Access Compliance Report

Public Rights-of-Way

Intersection ID: 21136	Main Street: SULKIRK_RD	Cross Street: SULSTONE_LN	Location: NE
ADA ID: D0F4DB7038FA	Ramp Type: Directional1	Initial Pass/Fail: Fail	Overall Compliance: No
		Severity Score: 8.75

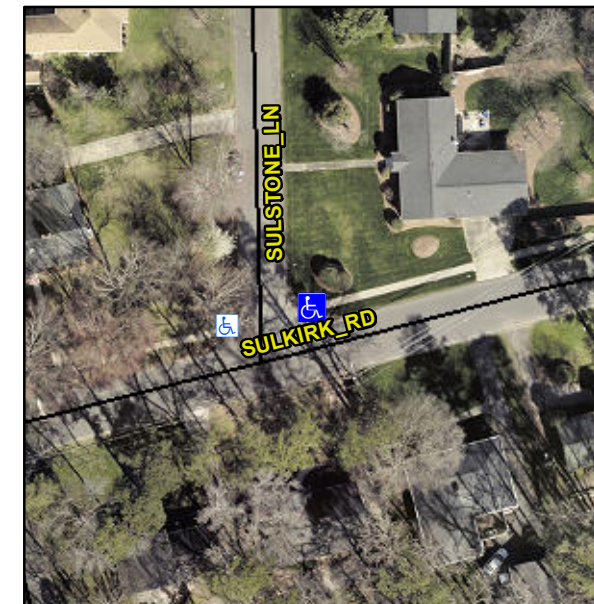
R304.5.1

Compliance	Description	Data	Compliance	Description	Data
N/A	Ramp Length (in)	37.0	N/A	Grade Break?	N/A
No	Ramp Width (in)	46.5	N/A	Grade Break Slope (%)	0.0
Yes	Ramp Slope (%)	1.7	N/A	Grade Break XSlope (%)	0.0
Yes	Ramp XSlope (%)	0.4			
N/A	Flare Type LT	N/A	N/A	Flare Type RT	N/A
N/A	Flare Slope LT (%)	N/A	N/A	Flare Slope RT (%)	0.0
N/A	Flare Traversable LT?	N/A	N/A	Flare Traversable RT?	N/A
N/A	Landing Length (in)	0.0	N/A	DWS Provided?	N/A
N/A	Landing Width (in)	0.0	N/A	DWS Contrast?	N/A
N/A	Landing Slope (%)	0.0	N/A	DWS Length (in)	N/A
N/A	Landing X Slope (%)	0.0	N/A	DWS Full Width?	N/A
N/A	Landing Curb? (Y/N)	N/A	N/A	DWS Offset LT (in)	N/A
N/A	Shared Landing?	N/A	N/A	DWS Offset RT (in)	N/A
N/A	Gutter Ponding?	0.0	N/A	Gutter Slope (%)	N/A
N/A	Gutter Lip Ht (in)	0.0	N/A	Gutter X Slope (%)	N/A
N/A	Painted X Walk1?	No		Road Slope (%)	2.9
	X Walk 1 Direction	To SW		Road X Slope (%)	0.1
	X Walk 1 Width (in)	N/A		Clear Space?	N/A

Remove & Replace Entire Ramp.
